RESPONSE TO REQUEST FOR INFORMATION

GEMCO | EXCESS WATER DISPOSAL (OCEAN OUTFALL) PROJECT

Figure 1: GEMCO Western Leases quarries, existing and proposed water storages and mining areas

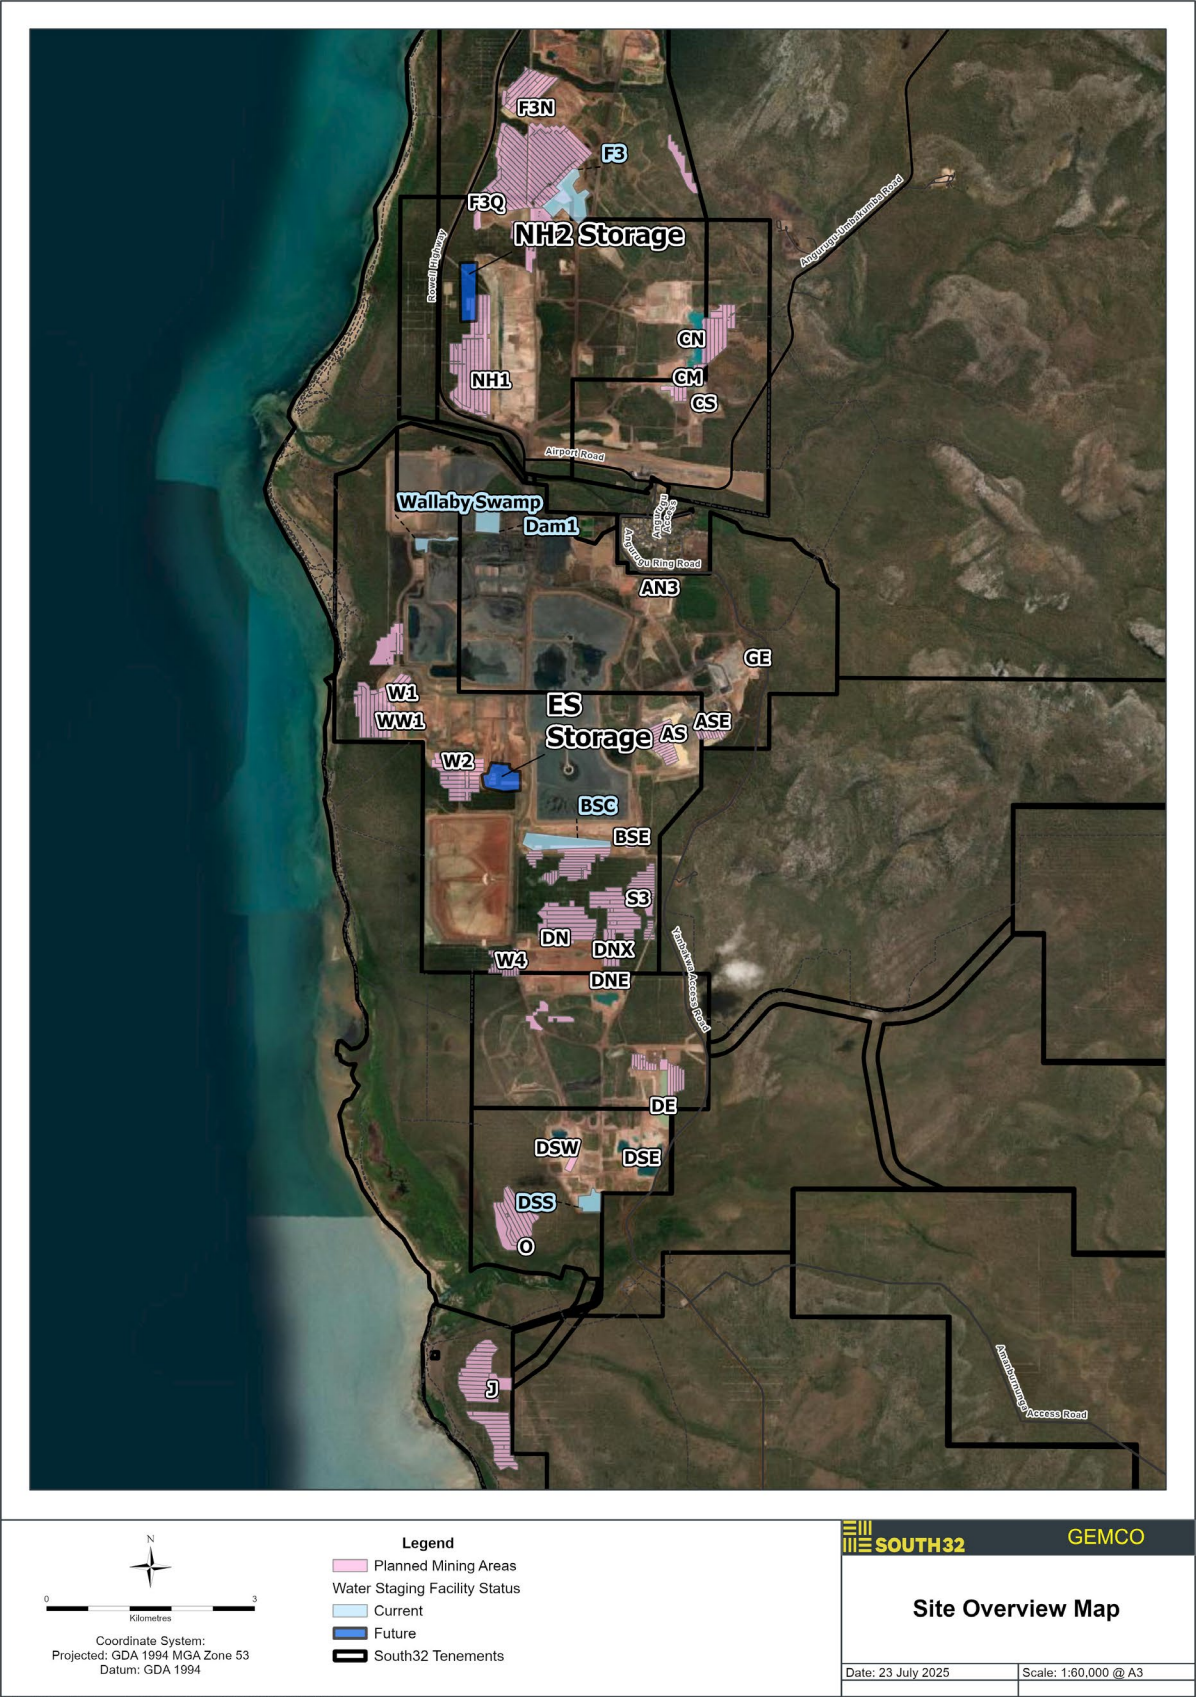
3. Provide further information on the onsite water management system upstream of the proposed pump and pipeline infrastructure, including, but not limited to:

b. identifying where pits are used as staged water storage prior to discharge (where relevant).	Current key water storages across the Western Leases include those at F3, BSC and DSS Water Storages (refer to Figure 1). Mining is planned to occur adjacent to F3 and BSC water storages from 2027 onwards, and for this reason the water storages must be moved to NH2 and ES quarry voids to allow for mining to continue. Whilst currently some excess water is discharged directly from individual quarries to bushland (in the order of <5% of quarry inflows) without storage, moving forward, the intention is to capture 90-100% of quarry inflows in water storages before using that water in the operation or discharging it. This will ensure maximum operational flexibility with respect to reticulating and managing excess water volumes and water quality requirements.

Figure 2: Proposed quarry depths (m below ground level) for the Northern Quarries

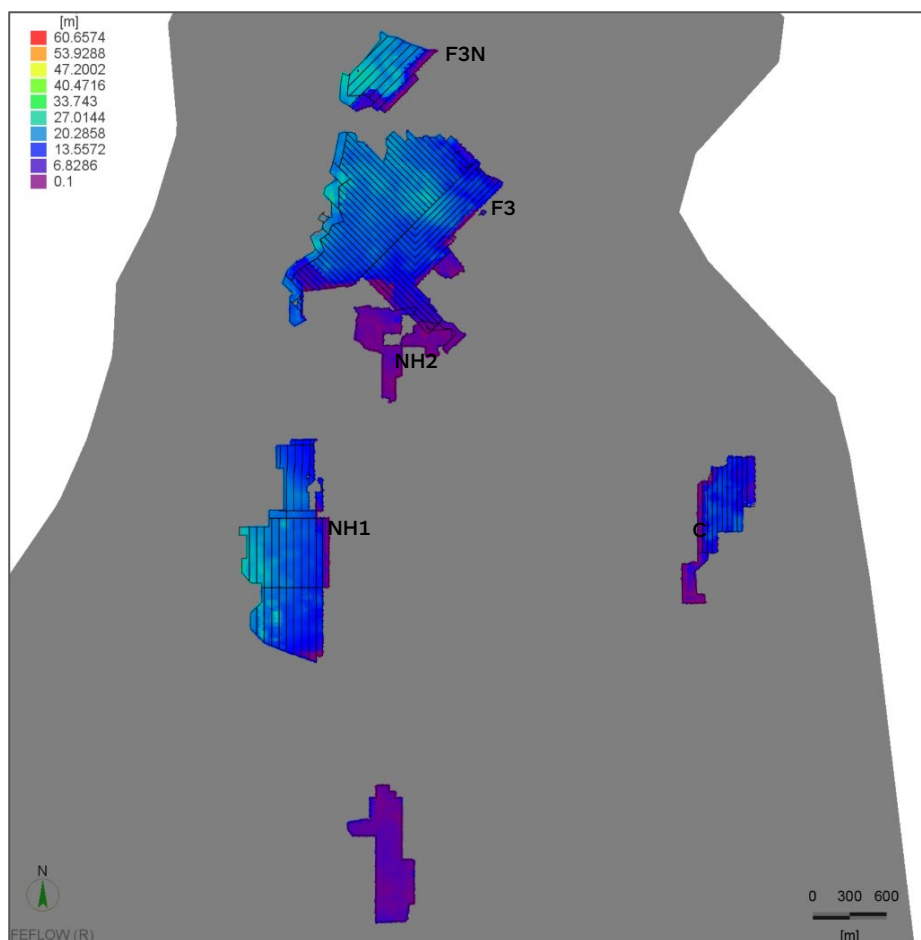
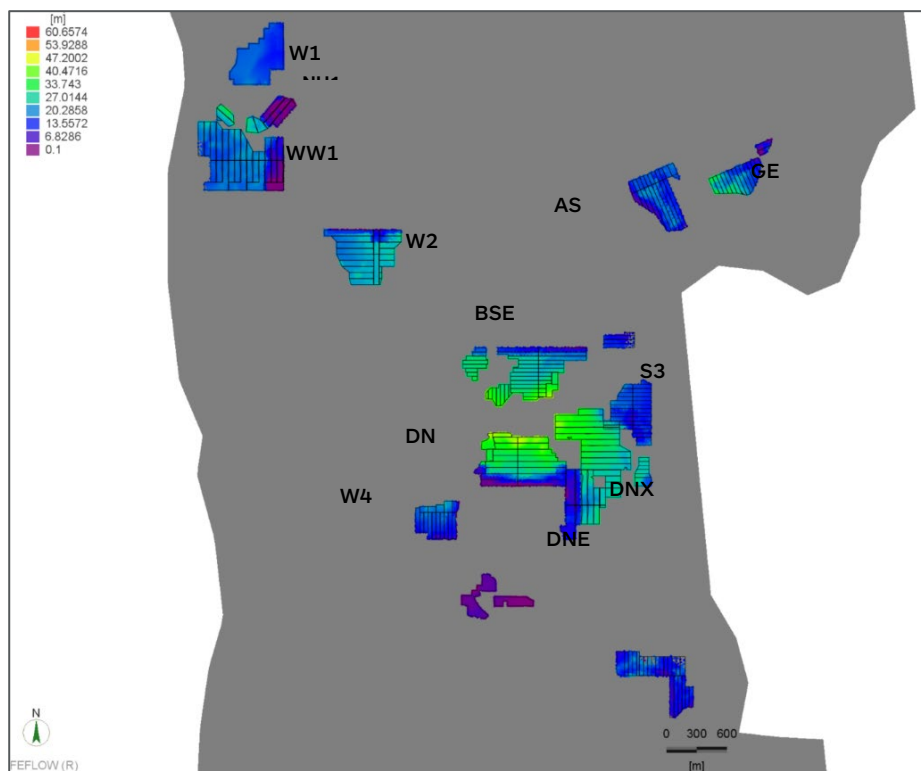
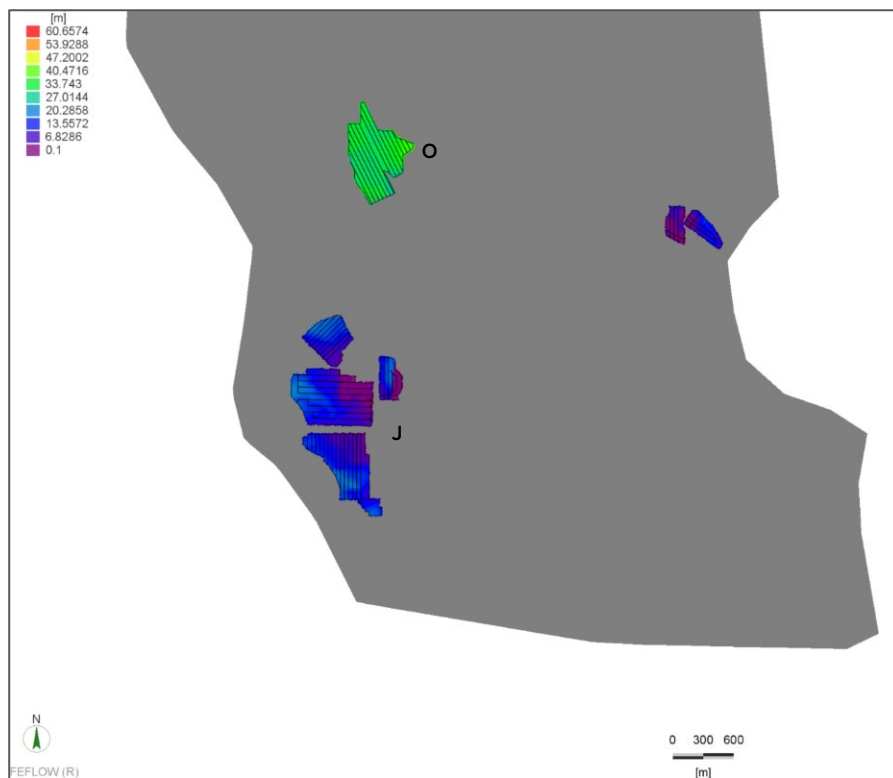
No. Request	Response
1. Provide an overview of the current and proposed mining operation relevant to the proposed action including pit location, footprint and depth.	GEMCO's mining operation occurs under, and is described in, its approved Mining Management Plan FY25 to Closure (MMP). GEMCO employs an open cut strip mining method to mine manganese ore, whereby the deposit is divided up into several different quarries. Within each quarry the orebody is exposed and mined in sequential strips that are typically between 40-60 metres (m) wide. Mining is undertaken cyclically at several (typically 10) quarries, with each quarry area in various stages of mining, backfilling and rehabilitation. To support the various mining stages and mine operations at GEMCO, a total of 22 quarries has active water management and pumping infrastructure currently in operation across the Western Leases. Quarry dimensions are determined by the nature and extent of the orebody, but are typically in the following ranges: • 200 to 1000 m long; • 60 to 80 m wide; and • 10 to 50 m deep. Figure 1 displays the general quarry areas and proposed mine quarry areas earmarked in the mine plan. Figure 2 to Figure 4 display the proposed approximate depths for each quarry development until the end of mine life.

Figure 5: Actual and predicted excess water volumes (FY24 to FY32)

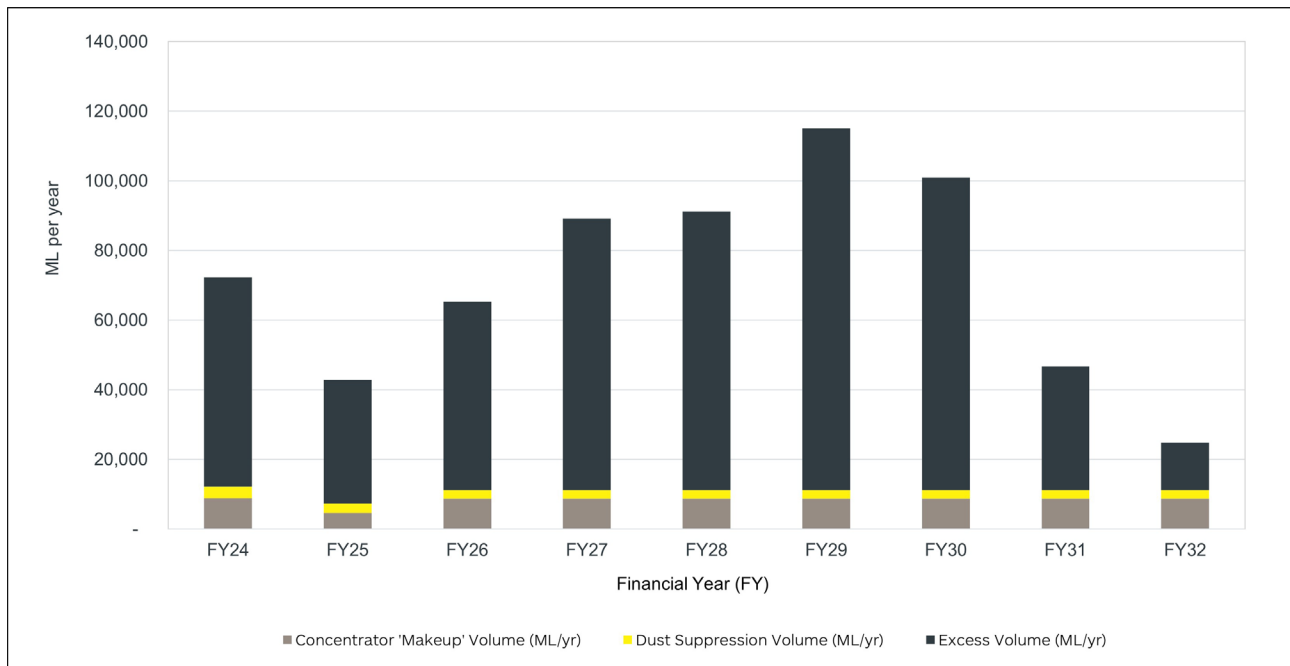
2. Provide the current and predicted site water balance including the existing and increased dewatering volumes.	Water balance and dewatering volumes GEMCO has a significant water surplus year-round. Anywhere between 8,000-13,000 megalitres (ML) of water is moved through the mine's water management infrastructure monthly. Future forecasts indicate that a significant water surplus will exist at GEMCO during the remainder of the operational phase with a lower-level surplus into closure. Typically, groundwater is responsible for the bulk of water generated at quarries, especially during the dry season when rainfall is negligible. Current average groundwater inflows are about 8,000 ML per month across the site. It is predicted that this will remain relatively consistent until mid-2028 and increase throughout late 2028 to 2029 (to 10,000 ML per month with peaks up to 12,000 ML per month) with the commissioning of new quarries. Groundwater inflow rates will reduce post 2029 as deeper quarries are exhausted. Notable quantities of surface water can also be generated during the wet season by intense or prolonged rainfall or tropical cyclone activity. For example, Tropical Cyclone Megan impacts in March 2024 resulted in around an additional 26 GL of excess water being generated and stored at the mine site, with similar additional significant volumes reporting from recharged aquifers to quarries in the months following. Runoff is currently estimated at 15-20% of total volumes reporting to quarries and water storages in a 'typical' wet season. Currently, on average per month, approximately 500-1,000 ML of water is consumed via concentrator operations, 200-400 ML is consumed via dust suppression and 3,500-6,000 ML is discharged to bush.

No. Request	Response
	The actual dewatering volumes during FY24 and FY25 and a base case forecast of water are provided in Figure 5³. This figure illustrates that the internal demand for excess water (makeup water and dust suppression), even at maximum demand, is relatively minimal, and is not sufficient to manage predicted water volumes. Relevantly, the Proposed Action will not of itself increase the volume of excess water released from GEMCO's quarries, but rather provide another point and method for the release of excess water. Water balance modelling GEMCO uses two main tools to quantify, predict and manage water volumes and movement across the Western Leases. These are the: • Operational water balance model (for short and medium term decision making); and • numerical groundwater model (to inform GEMCO's longer term approach to water management and dewatering). Operational water balance model GEMCO's operational water balance model is used to track and monitor quarry inflows, quarry water levels and water storage levels and to make management decisions over the short (day to day) and medium term (up to 2 years in advance). The model is used to: • maintain desired water levels in the quarries being mined to ensure dry and trafficable working conditions; • prevent quarries and water storages from overtopping; • maintain water storages within the operational ranges; • coordinate scheduling of the mine path; • quantify pumped volumes from quarries and water storages to coordinate the deployment of dewatering assets (pumps) and pipelines; • coordinate the disposal of mine water by discharge to bush; and • ensure bush discharge sites have sufficient rest periods (i.e. no discharge) during the dry season, thereby reducing risks to vegetation e.g. potential excessive inundation / water logging. The model has been developed with key input / output values including: • quarry inflow estimates measured from flowmeters; • water storage capacity curves for quarry and water storages (calculated by depth-volume relationship); • inflows and outflows to water storages, groundwater and bushland; • surface water runoff from overland flow, quarry and water storage catchments; and • evaporation. Each parameter input / output to the model is either measured (in the case of volumes) or estimated based on catchment scale relationships.
